UNIVERSAL DESIGN LIVING LABORATORY

August 15, 2011

**Re: Construction Storm Water Inspection at Universal Design Living Laboratory / Franklin County
Permit Number: 4GC03398 *AG**

Figure 3: Failed silt fence

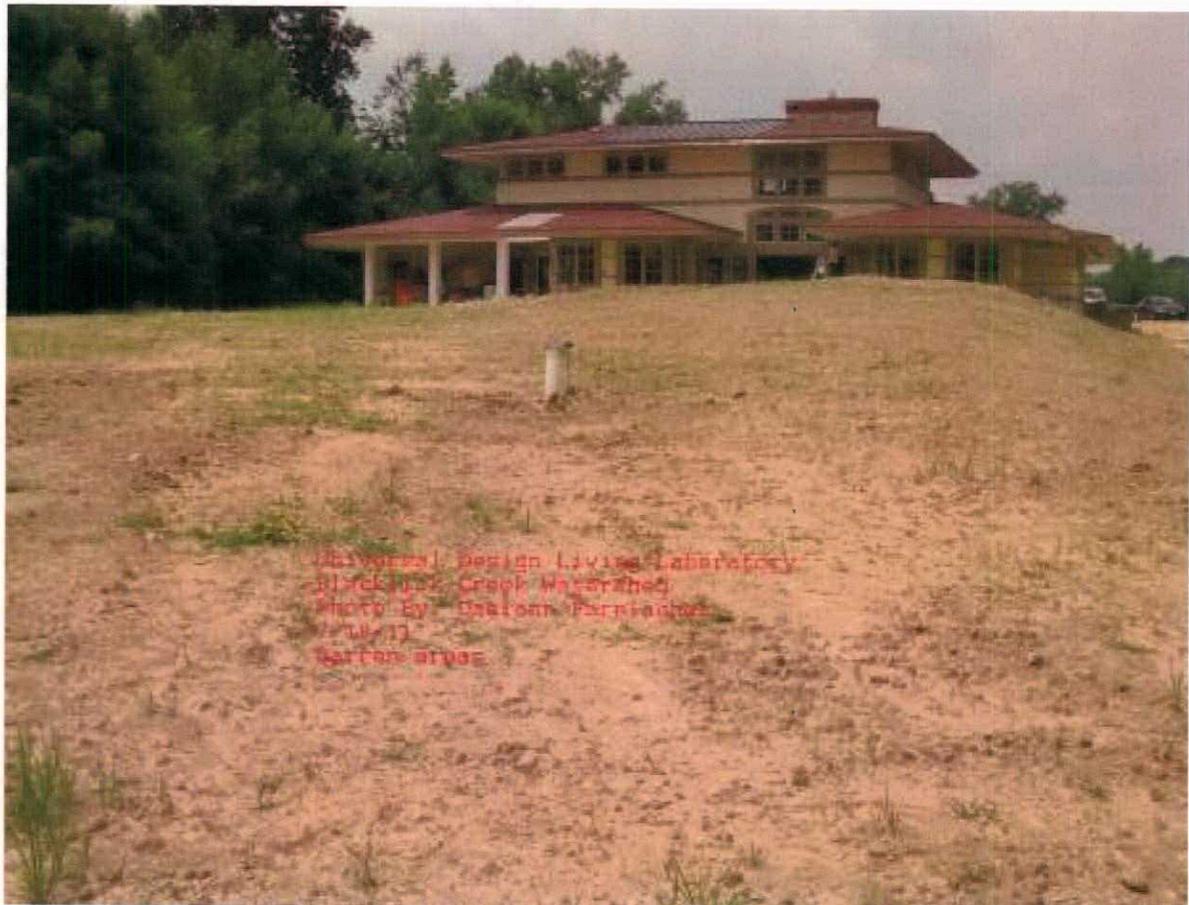
- Sediment is bypassing the bales of hay intended for sediment control (See Figure 1). Corrective measures must be implemented within three days of receipt of this letter.
- The silt fence along the back and left side of the site has failed and requires reinstallation (See Figures 2 and 3).
- Be aware the General Permit states that all barren areas which remain idle in excess of 21 days must be protected from erosion within seven days of the last earth disturbing activities. In addition, erosion protection must be implemented for all areas of final grade within seven (7) days (See Figure 4).
